Committee: Development	<b>Date:</b> 6 <sup>th</sup> June 2012	Classification: Unrestricted	Agenda Item No: 10.1
Report of: Corporate Director of Development and Renewal  Case Officer:		Title: Planning Application for Consideration	
		<b>Ref No:</b> PA/12/00844	
Jerry Bell		Ward(s): Adjacent to St Katharine's and Wapping

**Location:** 100 Minories, London EC3N 1JY

**Proposal:** Demolition of the existing buildings on site and the erection of a 10-

storey plus basement hotel (Use Class C1) comprising of 265 bedrooms together with ancillary restaurant, bar and retail facilities

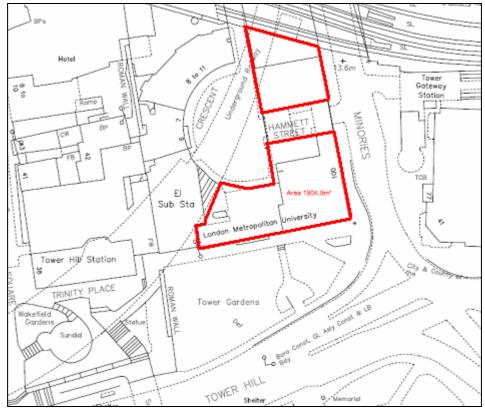
- 5.3 With particular regard to the introduction of a continuous, unrelieved frontage with marked horizontal emphasis on the south elevation of the building facing the WHS, this is considered to be discordant with the fine grain and character of the area and is therefore not considered to be an appropriate approach to a site of such significance. Furthermore, the cantilever of the upper floors of the facade creates an unacceptable overbearing impact at pedestrian level/from street view and exuberates the horizontality of the facade when seen from the south.

- 5.4 With particular regard to the recessed upper floor levels, it is considered that these have little relevance to the form of the buildings which form the immediate backdrop to the Tower of London. These would be particularly incongruous when viewed from the south, from which point the building is highly prominent and intervisible with the Tower of London World Heritage Site. The inappropriate use of materials (discussed below) would further emphasise the incongruous tiered approach to the uppermost floors.
